**NOTICE OF AVAILABILITY (NOA) OF
A DRAFT ENVIRONMENTAL IMPACT REPORT (EIR) FOR ST. JAMES PARK CAPITAL VISION
AND PERFORMING ARTS PAVILION PROJECT
AND PUBLIC COMMENT PERIOD**

Re: Response to Draft Environmental Impact Report

From: [Olivia Heir](#)
To: [Le, Thai-Chau](#)
Subject: Response to Draft EIR - St. James Park Capital Vision and Performing Arts Pavilion Project, SCH# 2016052074
Date: Thursday, July 2, 2020 11:15:45 AM

Figure 2-16. Depth to First Groundwater in the Santa Clara Subbasin

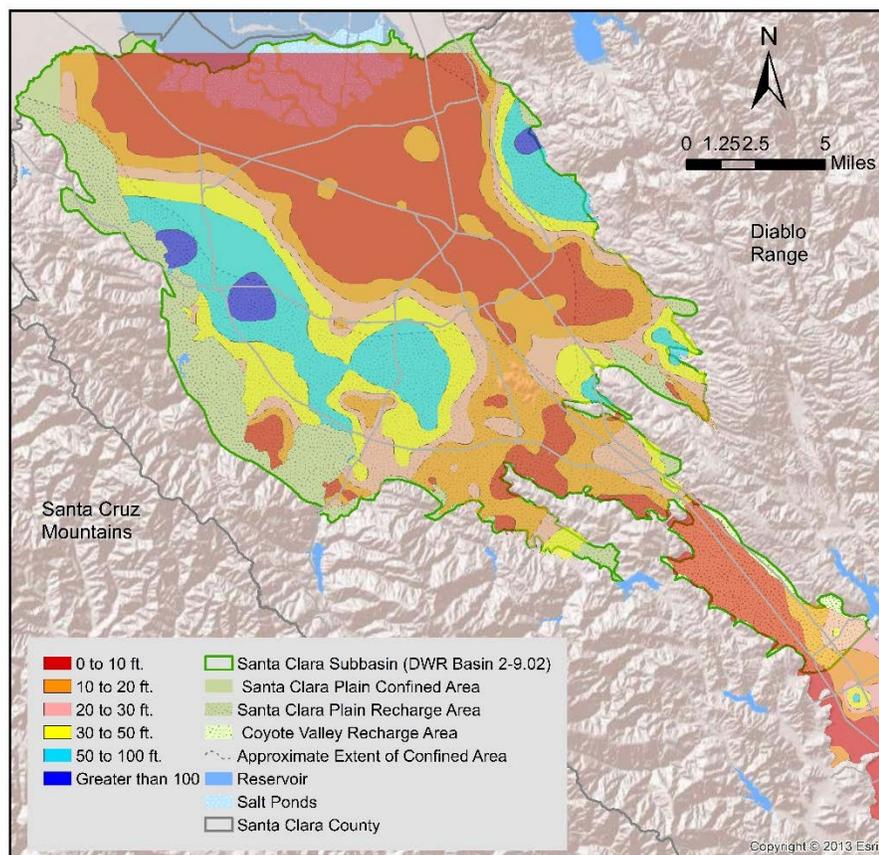
2. Section 3.10.1.2 Existing Conditions, Groundwater on page 116 describes the range of depths to groundwater within the region. This section should also include the depth to groundwater specific to the project site, which is approximately 0 to 10 feet below ground surface. Please refer to Figure 2-16 on page 2-17 of the Valley Water 2016 Groundwater Management Plan (enclosed).
